## Better Housing by Design Project: Potential Amendments to the Revised Proposed Draft

## Better Housing by Design Project: Potential Amendments to the Revised Proposed Draft

**6 – In the Alphet Historic District, change the application of the proposed RM3 and RM4 zones to better reflect historic development patterns**

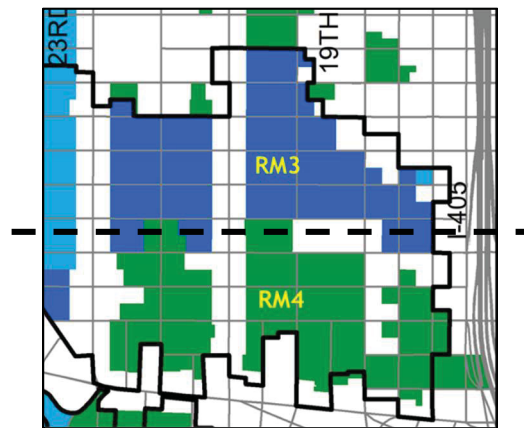
**Amendment Summary.** In the Alphet Historic District, apply the larger-scale RM4 zone to current RH areas south of NW Glisan/Hoyt, and apply the smaller-scale RM3 zone to areas north of this. This would be a change from the current zoning pattern, where there is an east-west division between the larger- and smaller-scale RH zones. There are two components to this change:

- (1) **Apply RM4 zoning to the area between NW 21<sup>st</sup> and NW 23<sup>rd</sup>, from Burnside to Glisan/Hoyt,** instead of the proposed RM3 zoning. This would increase the base FAR in this area from the current 2:1 FAR to a base FAR of 3:1 and a bonus FAR of 4.5 to 1, which would allow for a range of development similar to the scale of larger historic buildings in this area.
- (2) **Apply RM3 zoning to the area east of NW 21<sup>st</sup> north of Glisan/Hoyt,** instead of the proposed RM4 zoning. This would decrease the base FAR in this area to 2:1 (bonus FAR of 3:1).

**7 – In and around the King’s Hill Historic District, change the application of the RM3 and RM4 zones to better reflect existing development patterns**

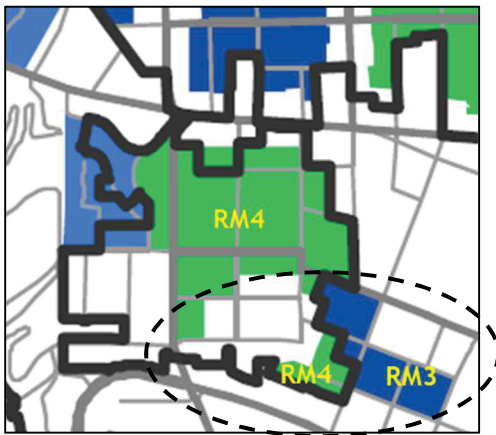
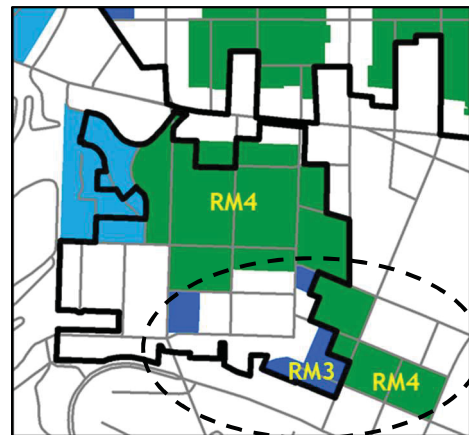
**Amendment Summary:** In the King’s Hill Historic District, apply the RM3 zone to properties with small historic structures at the edges of the historic district, and apply the larger-scale RM4 zone to currently RH zoned areas outside the historic district to the east. This will be a change from the current zoning pattern, where all of the current RH zoning in the historic district has a base FAR of 4:1 and was proposed for RM4 zoning. There are two components to this change:

- (1) **Apply the smaller scale RM3 zoning to properties with small historic structures at the southern edges of the historic district**, instead of the proposed RM4 zoning. This area has mostly smaller lots with small historic buildings (2-3 stories) and is adjacent to single-dwelling R5 zoning. This would decrease the base FAR in this area to 2:1 (bonus FAR of 3:1).

- (2) **Apply the larger-scale RM4 zoning to a three-block area outside the historic district to the east**, instead of the proposed RM3 zoning. This area is in the Central City Plan District, which provides a base FAR of 4:1. RM4 zoning would more closely correspond to this and other development standards that apply in this area. The primary change is that the block west of SW 20<sup>th</sup> between Salmon and Main streets would become eligible for the transit station area allowance for 100-foot building height (this block includes large existing buildings over 80-feet tall which exceed the current height limit of 65 feet). The other two blocks in this area are already provided with a Central City Plan District height allowance of 100 feet.
